DEPARTMENT OF BIODIVERSITY, CONSERVATION AND ATTRACTIONS REPORT

PROPOSAL	Extension to Bayside Kitchen Matilda Bay Café
LOCATION	Lot 8169 on Plan 171833 and Lot 14555 on Plan 32409 (Crown Reserve 17375), Hackett Drive, Crawley
COST	\$450,000
APPLICANT	Bayside Kitchen Matilda Bay (Warwick Lavis)
LANDOWNER	Conservation and Parks Commission (leased to Redbridge Pty Ltd – Matilda Bay Tearooms/Kiosk)
LOCAL GOVERNMENT	City of Perth
MRS CLASSIFICATION	Regional Open Space
DECISION TYPE	Part 5, <i>Swan and Canning Rivers Management Act 2006</i> , Ministerial Determination
ATTACHMENTS	1. Application and supporting documents (22 pages) 2. External referral responses: a) City of Perth (3 pages) b) City of Nedlands (1 page) c) Water Corporation (6 pages)
RECOMMENDATION	APPROVAL WITH CONDITIONS

2.2 Tree Details

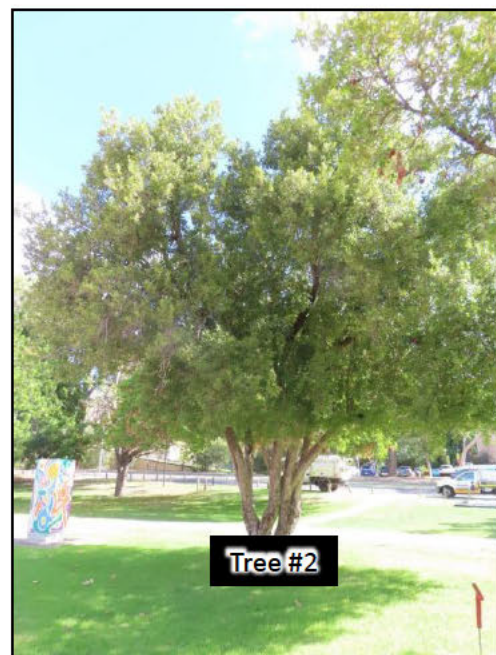
Species; Lillypilly (*Acmena smithii*)
Approx. Height; 6m
DSH; 57cm
DRF; 57cm
Canopy Spread; 5-6m north-south
5-6m east- west (4m east)
NRZ; 6.8m
SRZ; 2.6m

Species; Lillypilly (*Acmena smithii*)
Approx. Height; 8m
DSH; 46 & 33cm
DRF; 72cm
Canopy Spread; 7-8m north-south
8-9m east- west (5m east)
NRZ; 6.8m
SRZ; 2.9m

Based on the Plan Provided the majority of the development proposed looks to be over an area that already looks to have been disturbed at some stage over the Tree's life span. As such it is considered fair to assume that any root mass from the Tree that may have been in that area has previously been removed. Construction of the main aspects of the proposed development therefore looks likely to have marginal (if any) impact to the Tree.

Based on the Plan Provided encroachment into the NRZ of this Tree from the main aspects of the development looks to be marginal (<10%) and as such would not be anticipated to have any major impact to the future health or potential life span of the Tree, on the provision that the remainder of its NRZ is protected in accordance with AS4970 guidelines at all times during the construction phase of the development.

- 6.8 No clearing of vegetation (except for turf) is proposed as part of the development application.
- 6.9 There are two trees adjacent to the café (Figure 2). The applicant engaged a qualified arborist to assess any potential impacts to the trees from the proposed development. The arborist assessment report (**Attachment 1**) provided the following key provisions:

- Engagement of a suitably qualified arborist to undertake tree-sensitive excavation before general site works commence along the proposed alignment to undertake root pruning works.

- Methodology for the relocation/removal of the existing bike racks is to be subject to arboricultural input to ensure impact to Tree #1 will remain minimal during those works.

- Methodology for the relocation/removal of the existing light pole to be subject to arboricultural input to ensure impact to Tree #1 will remain minimal during those works.

- Proximity of proposed paving to Tree #1 is to be subject to findings from the exploratory excavations undertaken by the arborist.
 - All aspects of drainage including soakwells and any pipework required for soakwells is to be maintained outside of the notional root zone (NRZ) of the trees. Soakwells are not to be installed into the NRZ of either tree.

- Setting up of a tree protection zone (TPZ) for the trees prior to development works commencing in accordance with AS4970 guidelines. Both trees are recommended to be incorporated into the one single TPZ area.

- Canopy pruning to provide greater clearance for the proposed building is also recommended to be provided before general construction works commence.

- 6.10 The impact on the two trees can be managed through a condition requiring a Demolition and Construction Environmental Management Plan which is expected to include diagrams showing the TPZ and NRZs.

3. Prior to the commencement of works, all significant vegetation in and adjacent to the authorised work site shall be identified and protected by installation of Tree Protection Zones in accordance with *Australian Standard AS 4970-2009 - Protection of trees on development site* (**Advice Note 3**).

TREE PRUNING WORKS; CONTRACTOR COPY

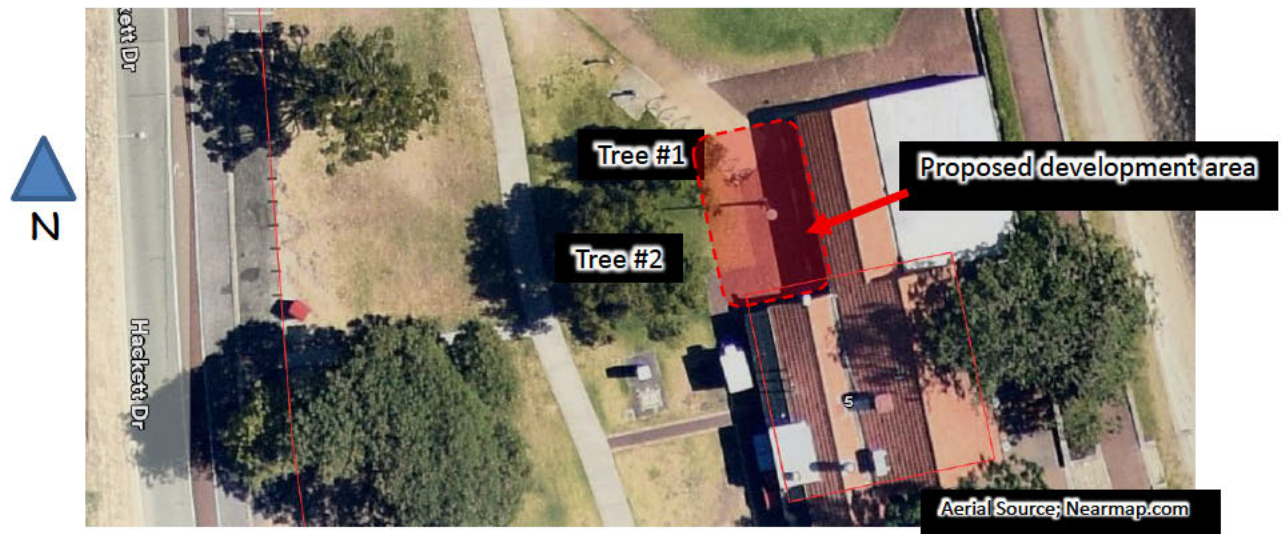
Tree #1; Lillypilly

Undertake selective canopy works to provide greater clearance from the proposed roofline; areas indicated on the image above.

4. All tree pruning works shall be carried out by an arborist (**Advice Note 4**).
5. Prior to the commencement of works, the final design and drawings are to be submitted to and approved by the Department of Biodiversity, Conservation and Attractions on the advice of the City of Perth, prior to applying for a building permit (**Advice Note 5**).

4. Regarding **Condition 4**, pruning shall be conducted in accordance with *Australian Standard AS4373-2007 - pruning amenity trees*, to protect tree health.
